Technical Bulletin

TB No: 036 | **Rev**: A | **Date**: May 12, 2006

Description: 9" Grabber Assembly Upgrade

Grabb	er, 9'	1
Fie № I-720457-1.ai		Model ECI/HCI/EMI	
Dwg. No. 1-720457		Rev B	Sheet 1 of 1
050505	VNL	Checked	a APP E

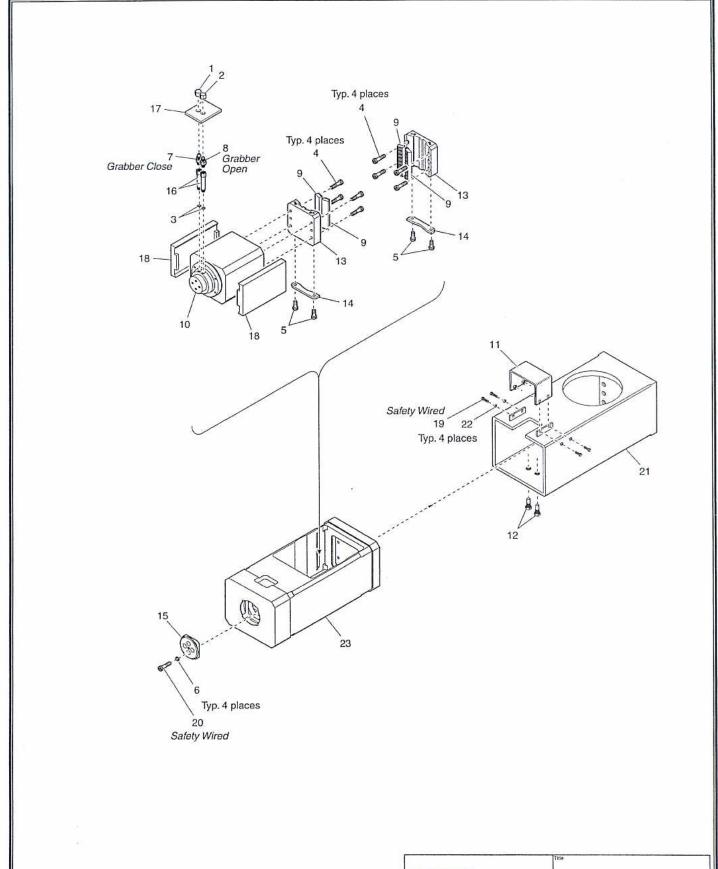
A redesigned clamping box has been introduced for all models of Tesco Top Drives that use the 9" Grabber Assembly. The new clamping box is a one piece welded construction designed to prevent mechanical separation of the front and rear bolted plates from the assembly. In addition to improving safety by reducing the number of overhead parts (plates and bolts), this redesign will also reduce assembly and maintenance time.

Install new 9" Grabber clamping box part number 810065 (see item# 23 on attached illustration). With the exception of the Bolt Retaining Plate (part number 10194, not required), all remaining parts including the cylinder, die holders, hydraulic fittings, etc, can be reused to create the new 9" Grabber Assembly part number 720457.

REMINDER: Perform appropriate checks and inspections on parts selected to be reused.
